ACRA & Ballymun Road North Residents Associations

COLLINS AVENUE STATION MODULE 2

Paul Cusack on behalf of both Associations.

Our suggested park-based station further north in Albert College Park

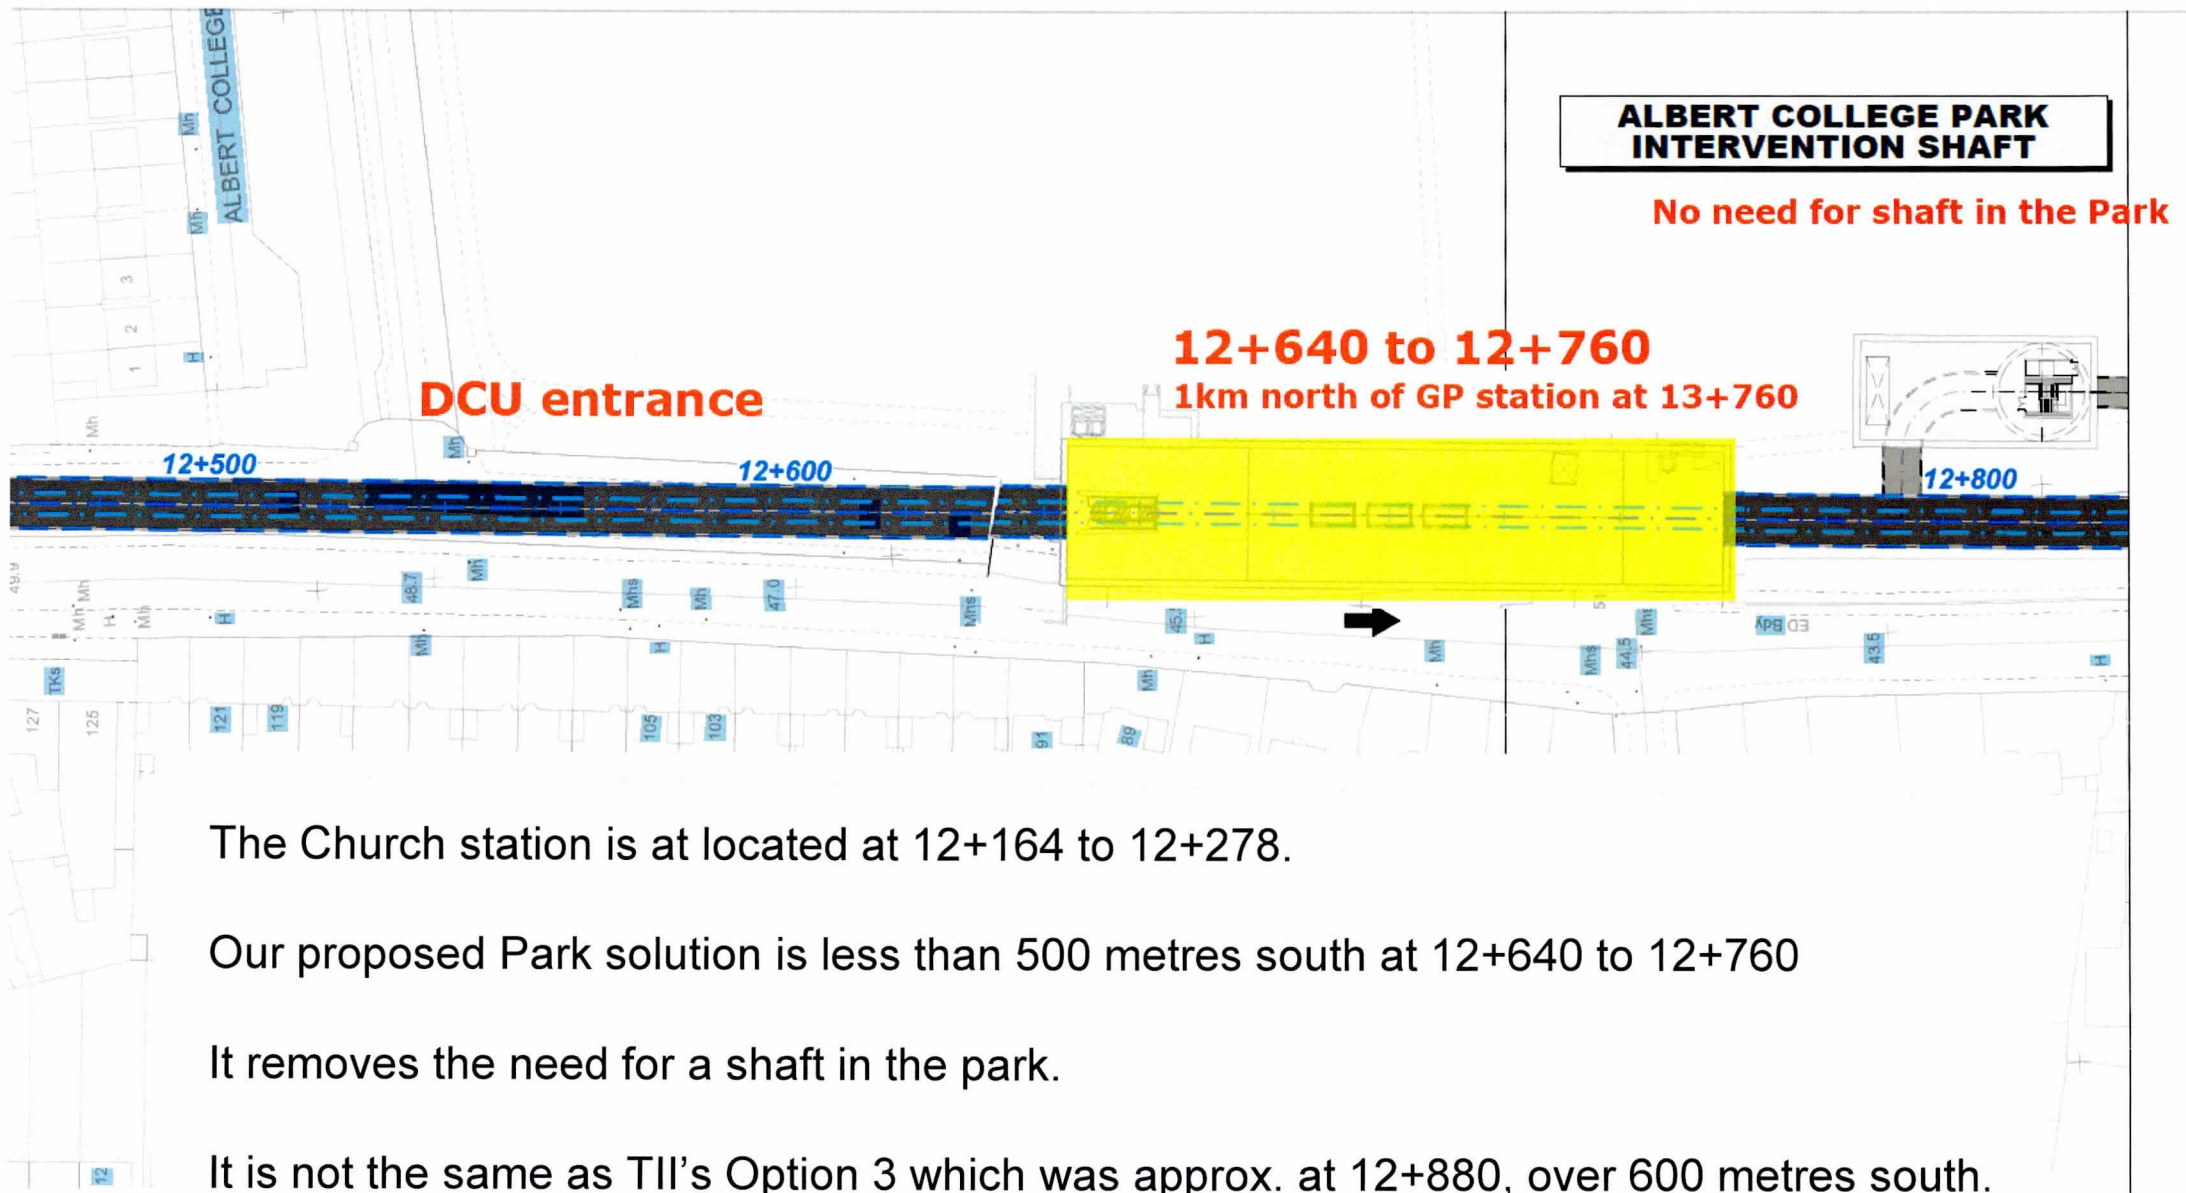
- We fully understand that the North-West corner would be more than the 1km distance from the Griffith Park Station and therefore the proposed location of a Park station would be situated at 12+640 to 12+760, just north of the middle park entrance and 1km north of Griffith Park station.
- A dual entrance station could possibly best suit this location as there is a dual entrance station at Charlemont.
